06PL029

**RE:** **Proposal 06PL029**

I have been reviewing the documents on the planning commission's meeting and agenda website and I am very concerned about proposal #06PL029 – South Terrace Subdivision.

Attachments: Photographs of topography  
Copies to: South Hill and Edinborough Residents

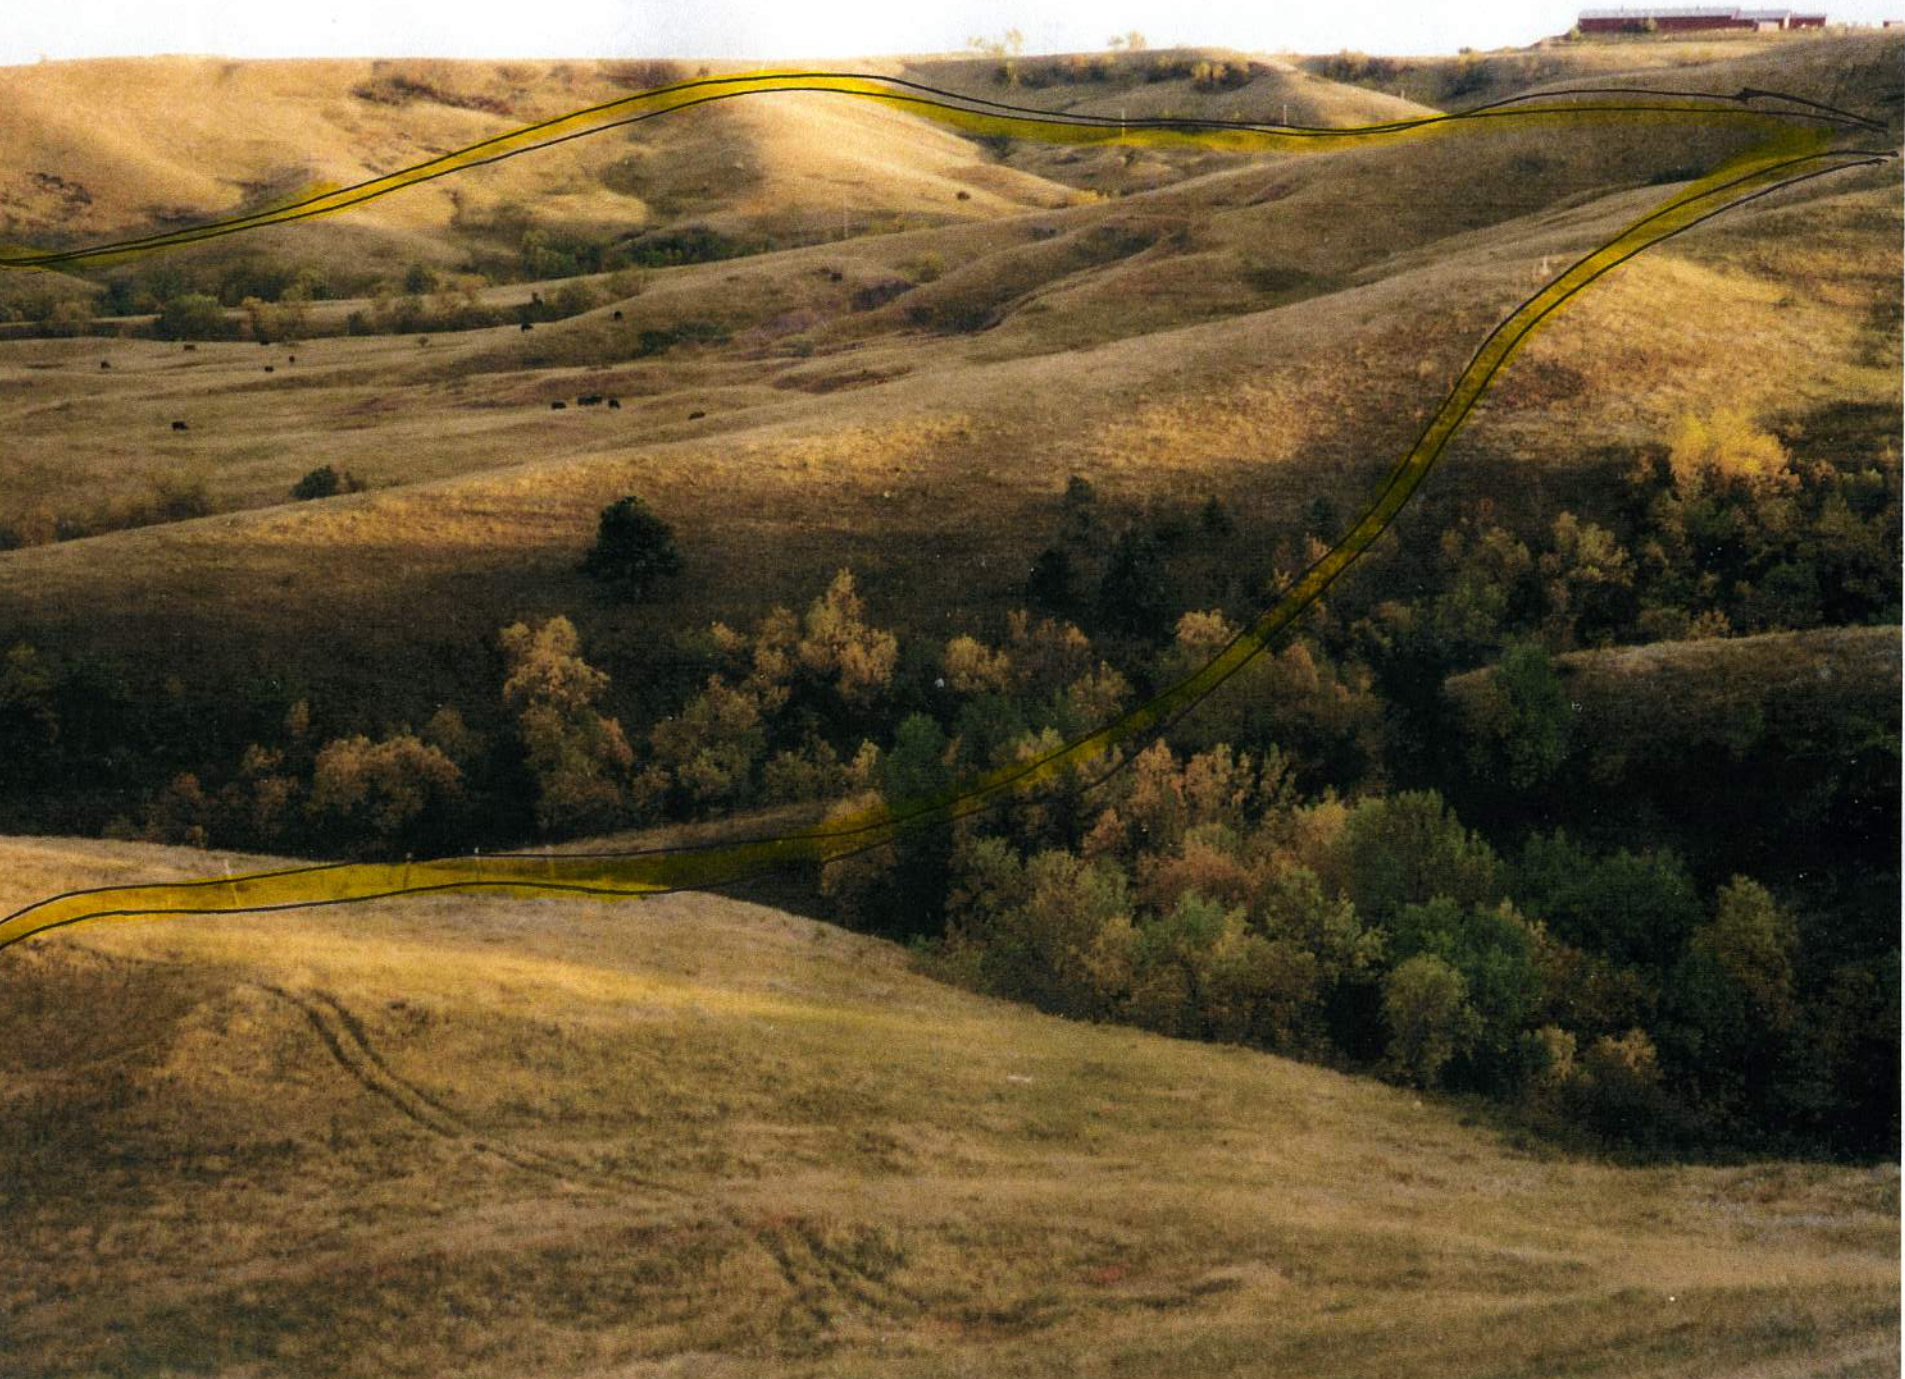
THIS AREA WILL BE LEVELED ON CURRENT PLAN.

THIS IS NOT A 20' RAVINE. THOSE ARE MATURE TREES

SPRINGS ARE LOCATED IN THE CENTER RAVINE

IT APPEARS HOUSES ARE BACKED UP TO THIS CLIFF

ANOTHER VIEW OF CLIFF
